Accessibility Survey

City of Glendale

Downtown Parking Lot #3

Inspected January 2008

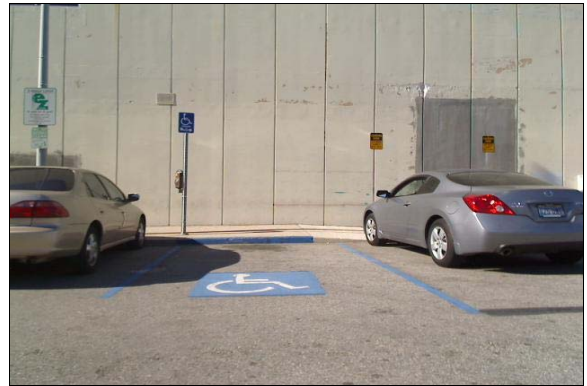
Finding: There is one (1) accessible parking space out of 67 parking spaces which does not meet the minimum number for compliance. The accessible parking space does not have an access aisle and there is no designated "van-accessible" parking space.

Full Rec: Three (3) out of 67 total parking spaces are required to be designated exclusively for accessible parking. Restripe the existing accessible space and create two additional accessible spaces, each measuring at least 108 inches wide and 216 inches long. Designate one parking space as "van-accessible". The van-accessible space shall provide an access aisle measuring at least 96 inches wide on the passenger side of the space. The two additional parking spaces shall each provide an access aisle measuring at least 60 inches wide, that may be shared. Add the words NO PARKING in 12 inch high white letters at the entrance to each accessible parking access aisle.

Accessible Parking

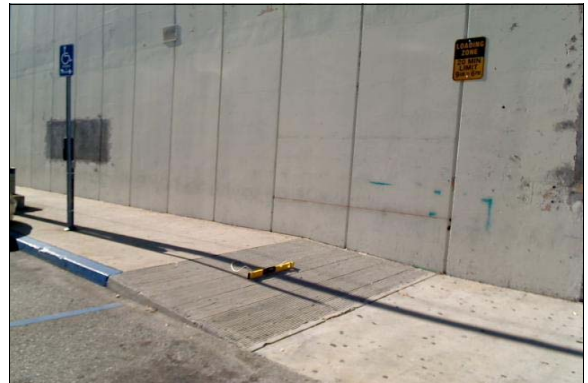
Finding: There is no wheel stop at the head of the accessible parking space to prevent encroaching into the minimum width of the accessible walkway.

Full Rec: Install a wheelstop at the head of the accessible parking space. Wheelstops shall be used to prevent vehicles from encroaching into accessible aisles or walkways, but shall not present addition encroachment into those areas (see CBC 1129B.4.3).

Accessible Parking

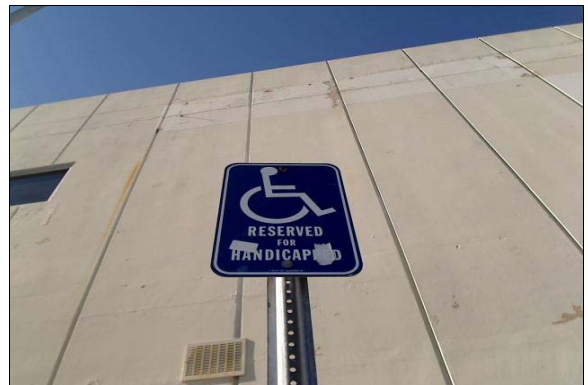
Finding: There is vertically-mounted signage at the accessible parking space, however, the sign uses the word "Handicapped".

Full Rec: Install a permanently posted reflectorized sign measuring 70 square inches that includes an ISA symbol adjacent to and visible from the accessible parking space (see CBC 1129B.5). The bottom edge of the sign must be mounted 80 inches from the ground surface so that it cannot be obscured by a parked vehicle (see CBC 1129B.5). Do not use signage with the word Handicapped.
